Memo

Date: Wednesday, July 26, 2023
Project: FEMA Flood Model/Map Review
To: City of Summerset, SD
From: HDR
Subject: Summary Mapping and Map Development Comments – Summerset, SD

HDR was hired by the City of Summerset to review and comment on the *Hydraulic Study Report – Meade County, South Dakota – Stagebarn Canyon Alluvial Fan.*, dated June 2023.

Figure 1. USGS StreamStats screen shot of the primary watershed entering from Stagebarn Canyon

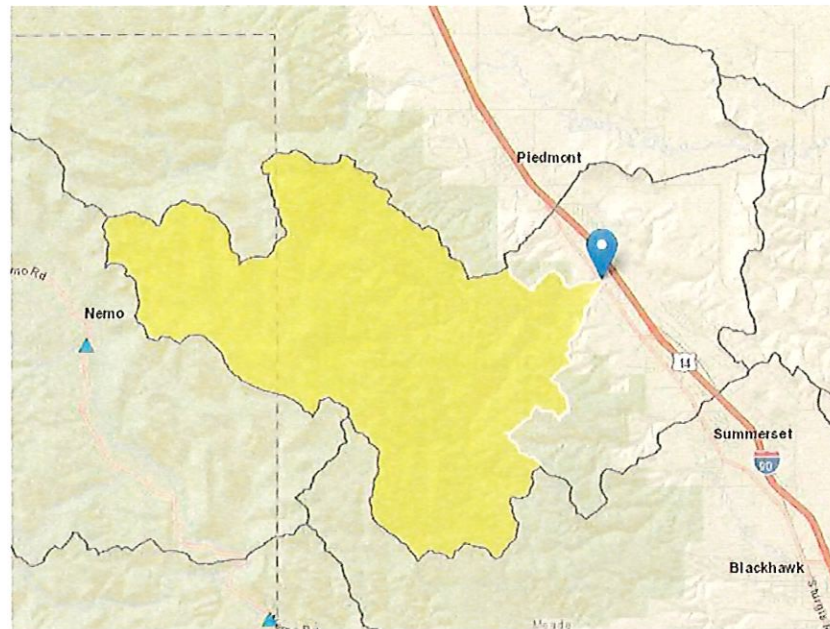
USACE (2017) notes that typically a hydrologic model with physically based or regionally informed runoff transform parameters would be developed to generate hydrographs. FEMA (2019) continues that rainfall-runoff models are applicable and necessary for studies where a flood hydrograph is required, and in studies where storage behind road embankments may be significant in determining flow and stage. Why was a regional regression-based approach selected instead of a model-based approach?

Figure 3. Hydrogeologic settings for the Black Hills region (excerpt from Sando et al. (2008))

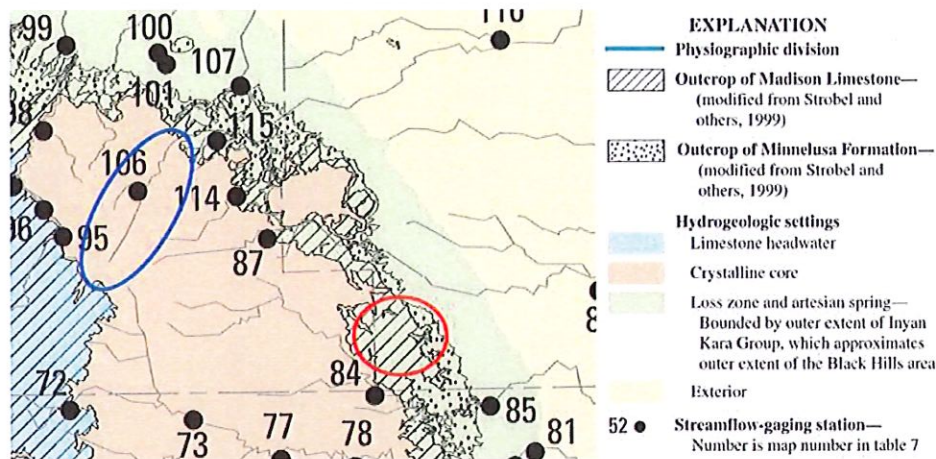
Stagebarn Canyon appears to be completely within the "Loss zone and artesian spring" as shown in Figure 3 (red). Sando (2008) indicates that loss zones only exhibit active discharge when upstream channel flows exceed the areas channel infiltration capacity. This results in limited response to frequent events and a reduction of peak flows in the downstream direction. However, these effects may be less prevalent for large events. The crystalline core area in Figure 3 exhibits a larger peak flow potential and more direct response to short-term precipitation. The blue circle (Figure 3) shows the approximate location of Whitewood Creek. The 1995 event at Whitewood Creek was selected due to its conservatism regarding duration and flood inundation. This location may not result in a similar response to the Stagebarn Canyon. Additionally, this site is 45 sq. miles in drainage area, is this hydrograph appropriate for application to all (or any) of the four inflow locations?

Figure 4. LiDAR DEM comparison

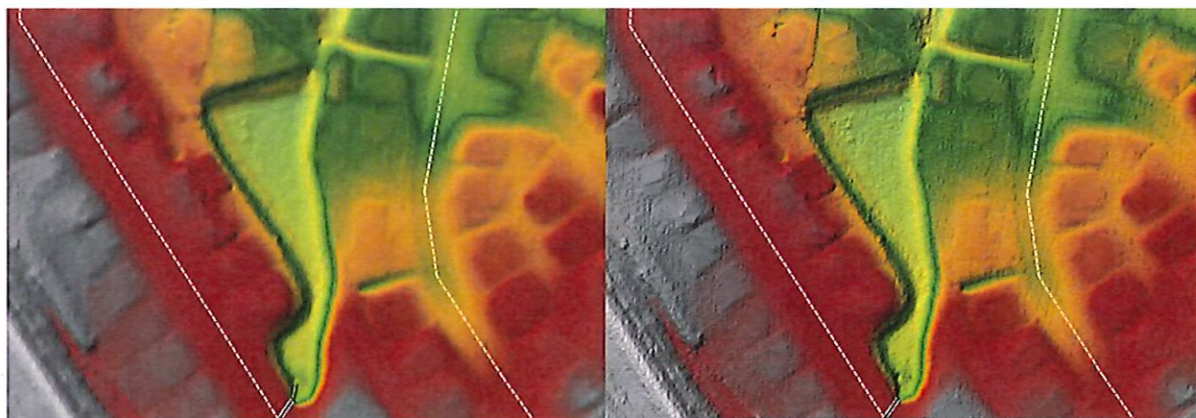
Development of the terrain (LiDAR and channel bathymetry) did not create a continuous bathymetric surface, rather each cross section was included independently into the terrain. By assuming cross sections are connected and a stream is continuous, an interpolation surface can be created connecting all of the cross sections along a water feature. This allows for representation of bathymetry for an entire reach. Why were cross sections used independently instead of together?

Through the HEC-RAS "Download Terrain Data" tool and selecting "USGS" terrain products published by the USGS can directly be downloaded. For this location both the one-meter resolution data or a finer 0.5-meter resolution (noted as original resolution) can be downloaded. Application of the 0.5-meter resolution terrain data would improve representation of hydraulic conveyance and improve inundation mapping. Figure 4 provides a comparison between the 0.5-meter resolution LiDAR product and the combined 1-meter surface used as part of the 2023 study.

Figure 5. Terrain Modification Example

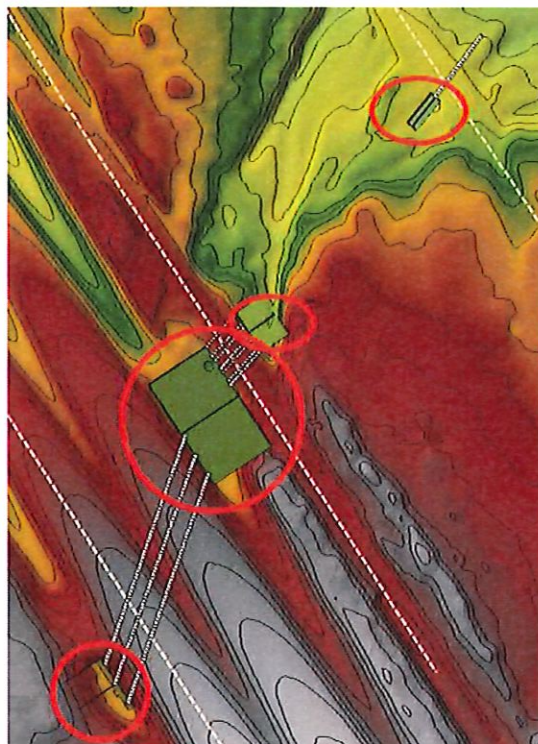
Twelve terrain modifications were used but there is no documentation for their purpose (example shown in Figure 5). Do surveyed cross sections support modification of the elevations upstream and/or downstream of the structures?

Figure 8. Overview of spatial data for model set up

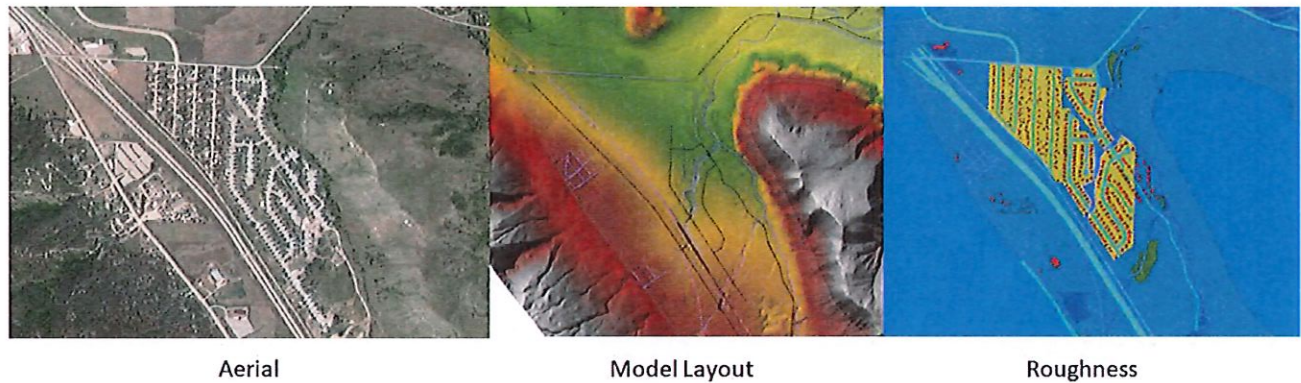
Manning's roughness polygons targeted at describing buildings do not capture all structures as shown in Figure 11. The area in blue is described as "grass-short" and has an efficient roughness of 0.035. Consider adjusting the roughness value to represent the areas where there are buildings.

Where buildings are included as high roughness areas through development, the grassed space around the buildings are represented as 0.07 (Figure 12, yellow area). These areas may be better characterized with a short grass roughness value.

Figure 10. Roughness exemplified from Telluride Street crossing looking northeast

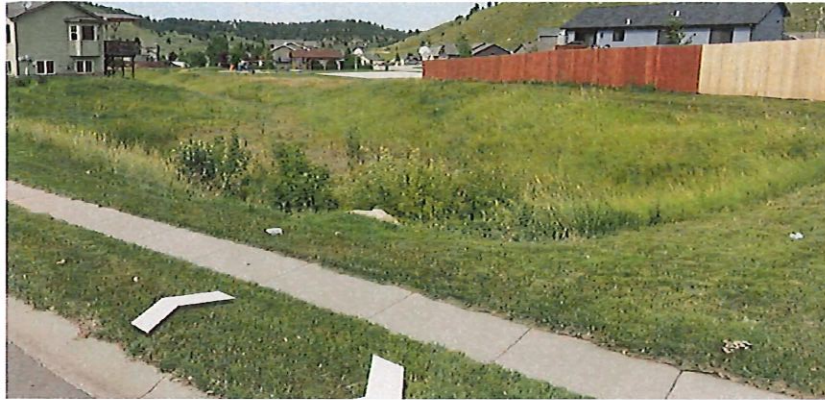
Manning's Roughness Coefficient of 0.038 for all channels is appropriate for some but overly conservative for others. Figure 9 and Figure 10 provide a few examples through the development that would likely be more efficient than 0.038 especially in flood flows.

Figure 13. I90-S 2D/SA connection multiple crossings

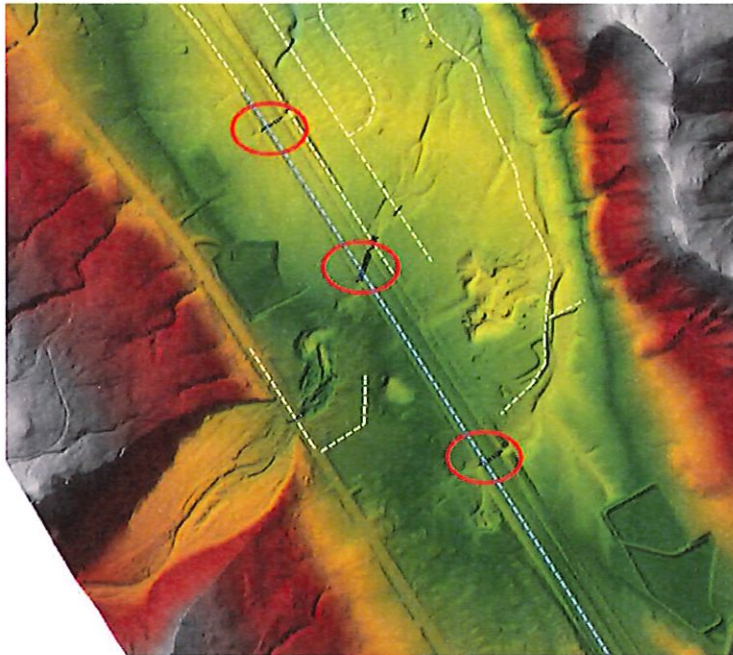
I90-S 2D/SA connection (Figure 13, blue line) includes three independent reach crossings (red circles). Although the model configuration used in this analysis allows flow to pass appropriately, the headwater/tailwater and discharge dynamics for all the structures are merged together and diff

icult to disaggregate. Splitting these into three crossings allows for improved understanding of capacity and backwater caused by each structure and improves the capability for mitigation planning.

Figure 14. 2D/SA connection at the dam location requiring re-location

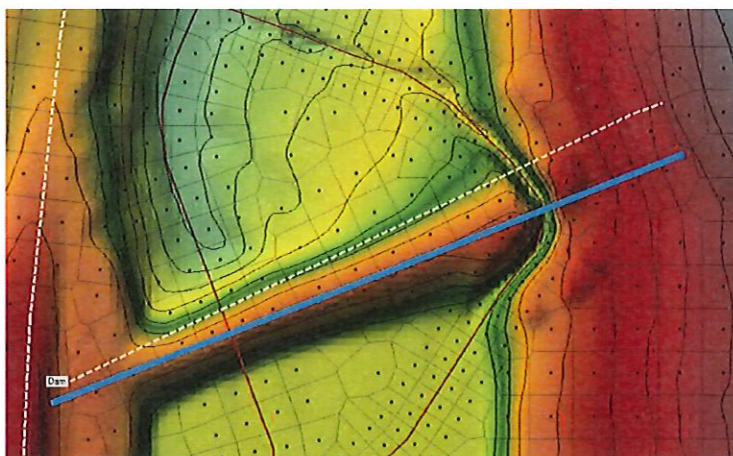
2D/SA connections and breaklines occasionally are not located appropriately to capture the high point, resulting in premature overtopping of high point features. Blue line represents a better placement of the connection. Adjust the 2D/SA connections and breaklines to better represent the overtopping.

Figure 15. Breakline refinement to contain premature overtopping flows

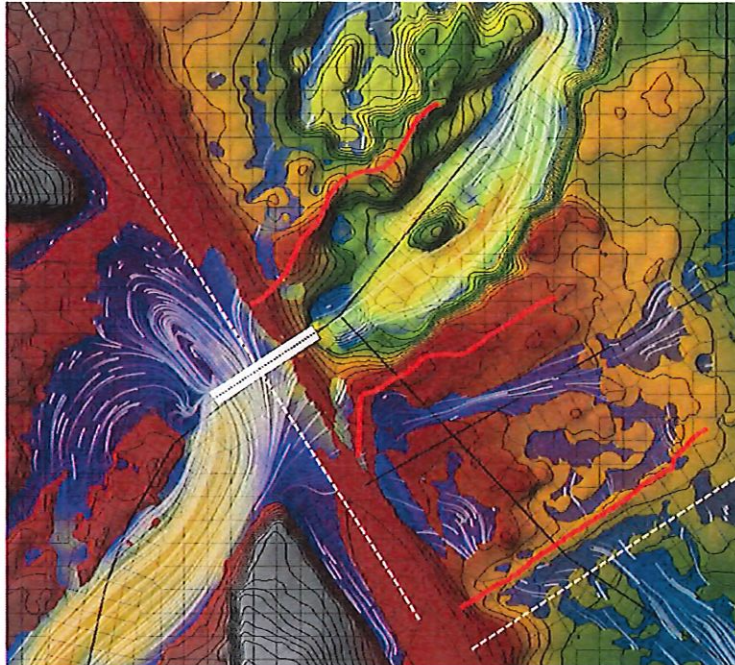
A number of elevated topographic features which will have a hydraulic impact on hydraulic conveyance and inundation extent are not captured with the current breakline and 2D/SQ connection configuration. Figure 15, Figure 16, and Figure 17 provide a few examples of topographic features that should be captured by breaklines, or locations where the actual high point was not captured with a current breakline. Refine the breaklines to capture the elevated topographic features.
